To: Development Permit Panel

File: DP18-797026
HA18-797029

Re: Application by Eric Stedman Architect for a Development Permit and Heritage Alteration Permit at 12060 & 12080 1st Avenue

Staff Report

TREE RETENTION AND REMOVAL PLAN

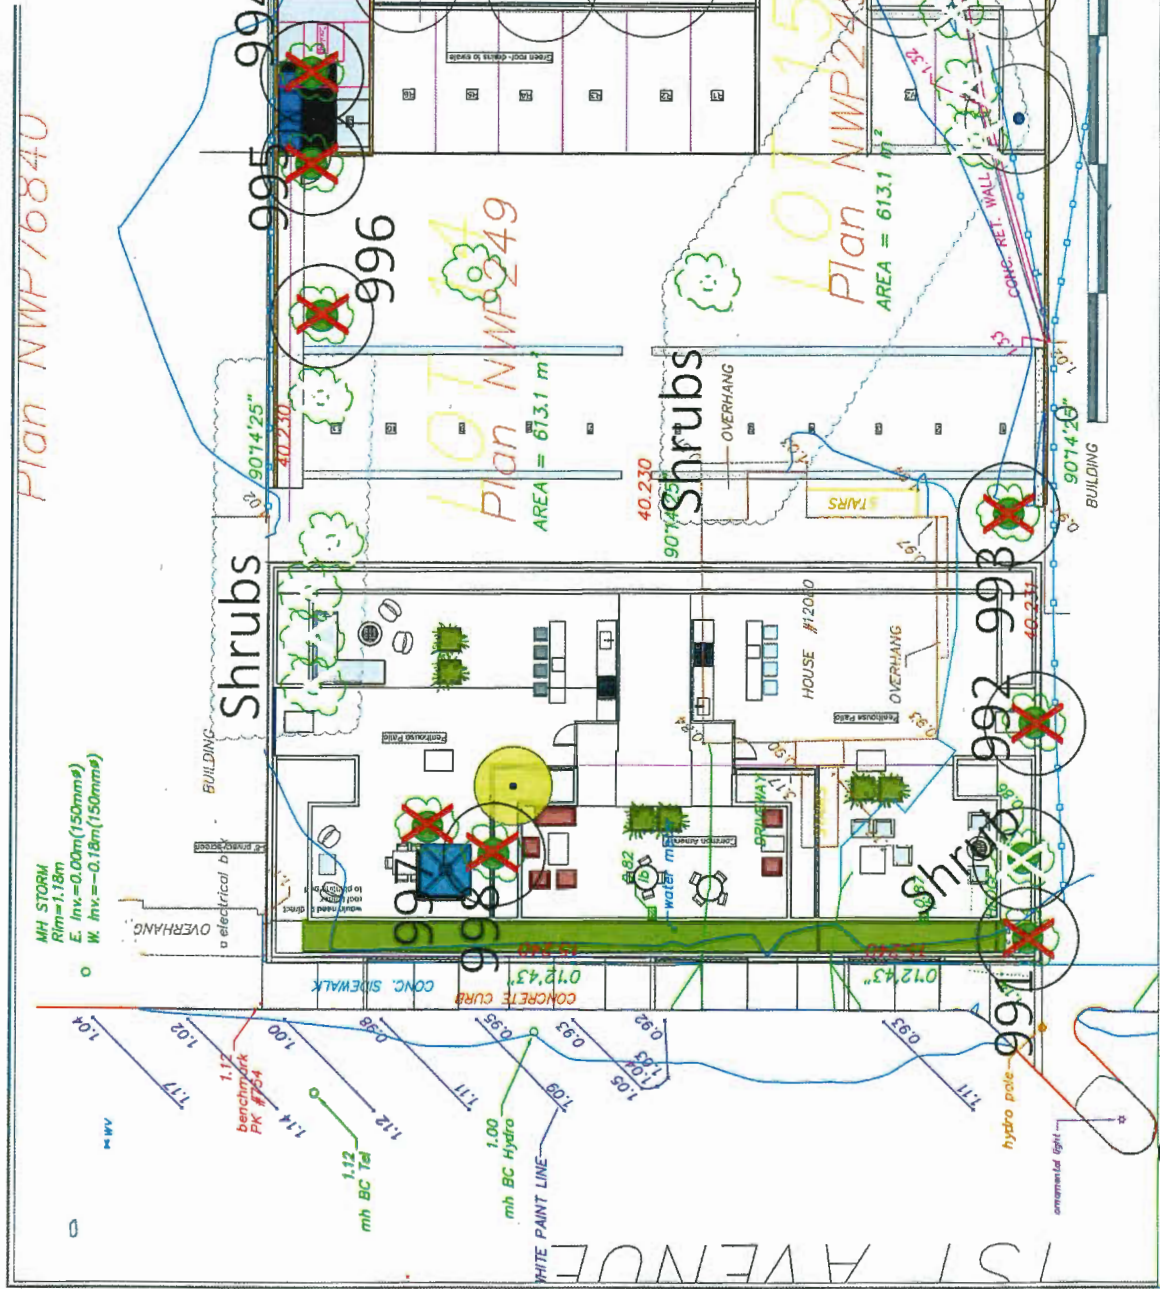
- One (1) tree (tag# 993), Corkscrew Willow, is located on the development site. This tree is in good condition but is located in the side yard. The tree is in conflict with the proposed development. Remove and replace.

- The applicant wishes to remove eight (8) on-site trees. The 2:1 replacement ratio would require a total of 16 replacement trees. The landscape plan shows 16 new trees to be planted on the site: 12 replacement trees in the parking and landscaped area at the rear of the

Drawing Title:
 ROOF PLAN

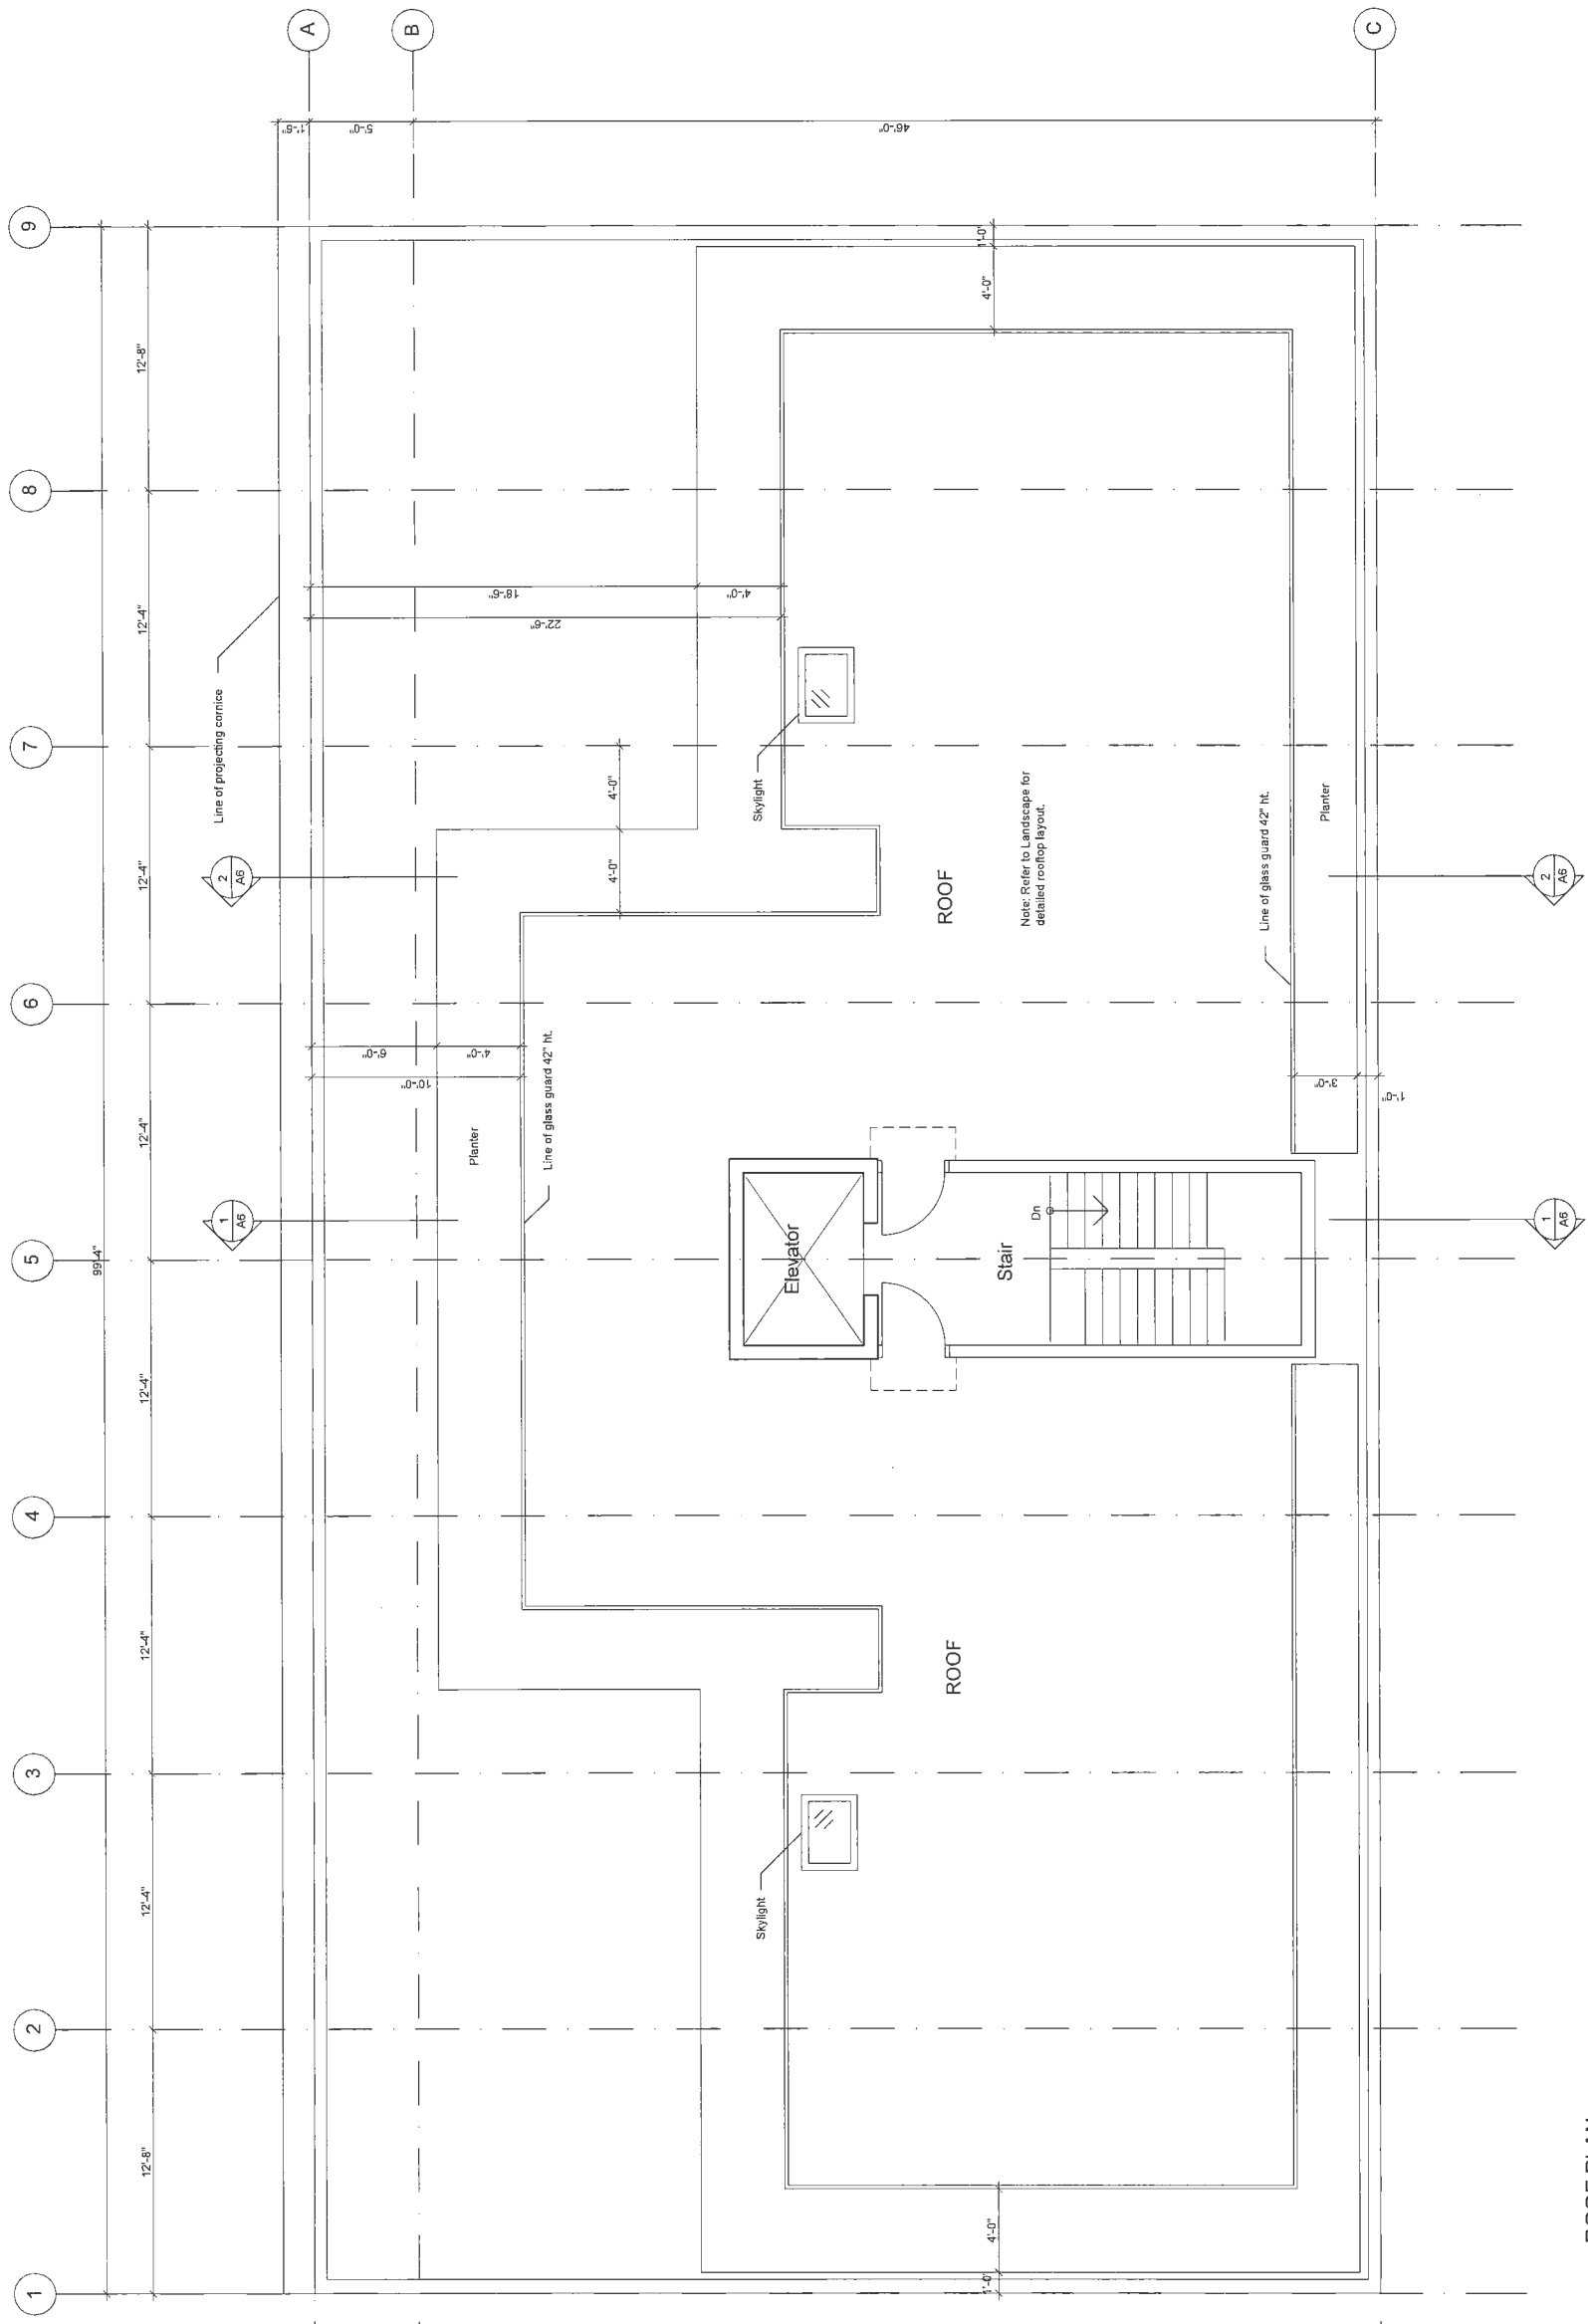
2. Vary the provisions of Richmond Zoning Bylaw 8500 to:
 - a) Increase the maximum permitted building height from 12 m to 14 m to allow stair and elevator access to the rooftop outdoor amenity area.

- *The Steveston Area Plan Development Permit Guidelines encourages use of roofs as outdoor living spaces. An elevator access is provided to ensure the space is accessible for all residential users. The rooftop deck includes a communal outdoor amenity area as well as urban agriculture planters for use of all residents. All the residential units are designed to be accessible with potential to be easily renovated to accommodate a future resident in a wheelchair.*

- *The proposed location and height of the stair and elevator structures are consistent with the Steveston Area Plan Development Permit Guidelines for the Steveston Village Character Area. The Steveston Area Plan requires stairs and elevator structures be well integrated with the overall design of the building and setback from all roof edges to a minimum distance of 1.0 m. The structures will be treated with the same cladding material and the proposed parapets help reduces their visibility.*

- *The applicant has provided a view analysis to show that the proposed rooftop deck access structures will not be visible from Moncton Street and 1st Avenue.*

Drawing Title: Landscape Concepts Ground Level
Project North: CJK
Checked By: CJK
Scale: 1/8"=1'
Job No.: 2017-0810
Sheet No.: L1

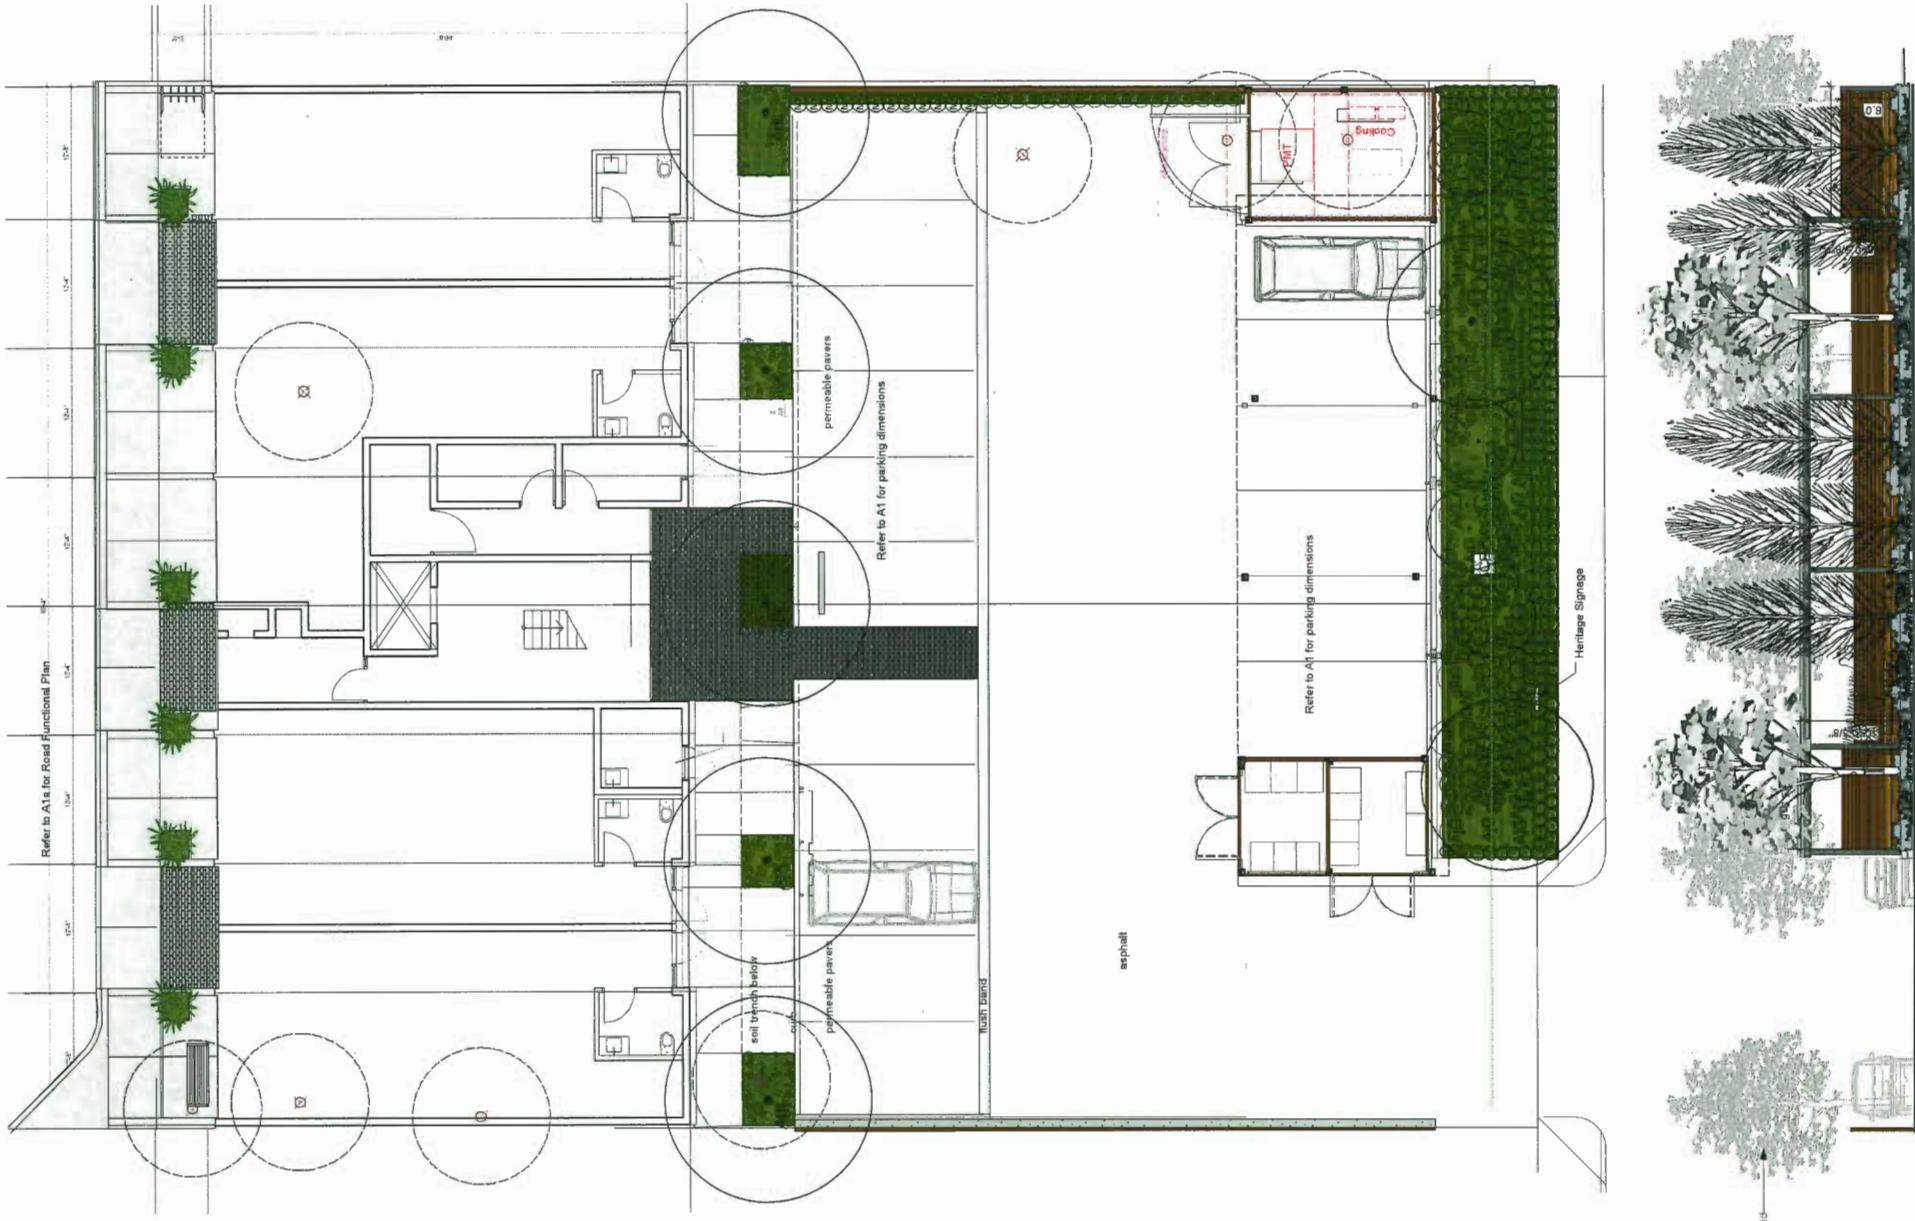
- appreciate the proposed linear pavers on the site frontage; however, consider running the linear paving treatment the whole length of the covered area frontage, excluding the sidewalk; also consider relocating the planters in line with the columns and not at the entries to the commercial units to allow a clear path for pedestrian circulation;

- appreciate the proposed landscape elements in the project; also appreciate the proposed landscaping at the rear of the site to celebrate the previous greenery on the site;
- nice compact project appears to work well;
- concerned about the provision for a common breezeway from front to back of the building; could work more successfully in a larger project but may not be appropriate in the Steveston area which is characterized by meandering passageways; consider redesigning the ground floor lay-out to provide a common passage connecting the rear parking area to the First Avenue and a lobby which includes the proposed location of the elevator and stair;

The linear pavers layout is retained to designate storefront and residential entries. The planter locations are adjusted.

No common breezeway front to back is proposed. It is not suggested in any planning or zoning documents as appropriate for this site. Combining the residential entrance with a public access through the building presents significant CPTED issues and has not been incorporated.

Landscape plan has been revised to incorporate paving designating a pathway.

Drawing Title: Landscape Concepts Roof Top Level

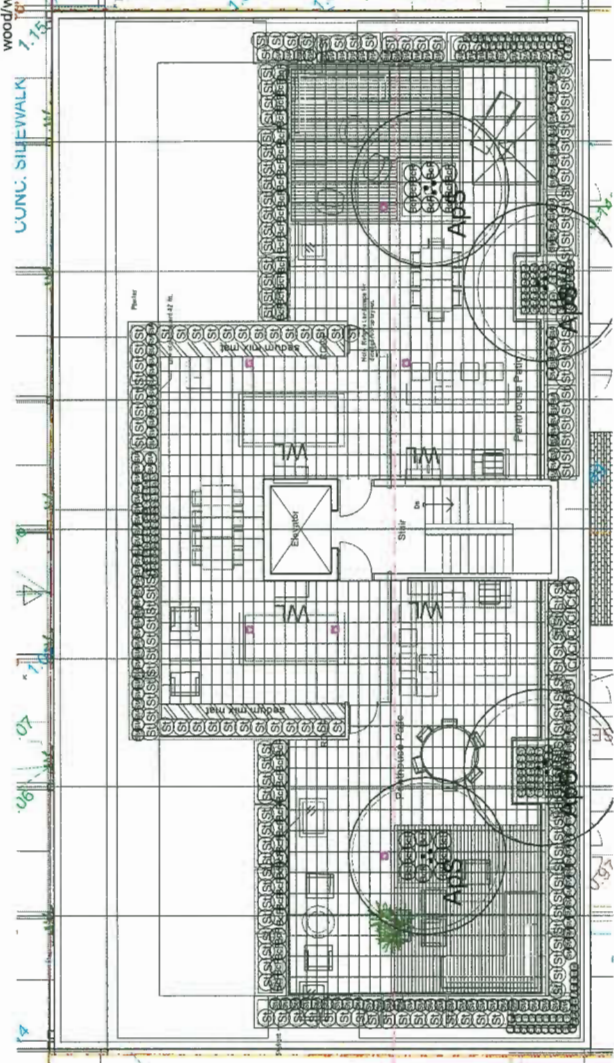
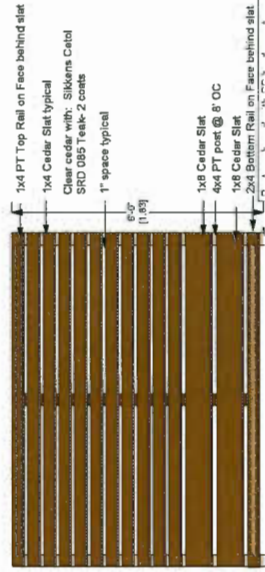
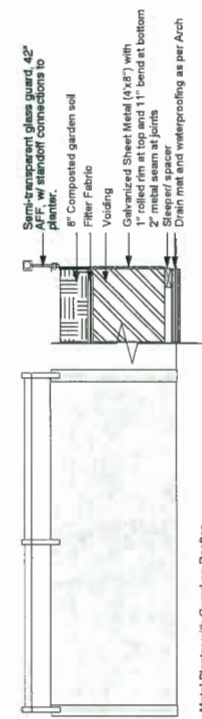
- consider installing an additional pair of trees on either side of the roof deck to screen the planting areas in the common outdoor amenity area;

Landscape plan has been updated.
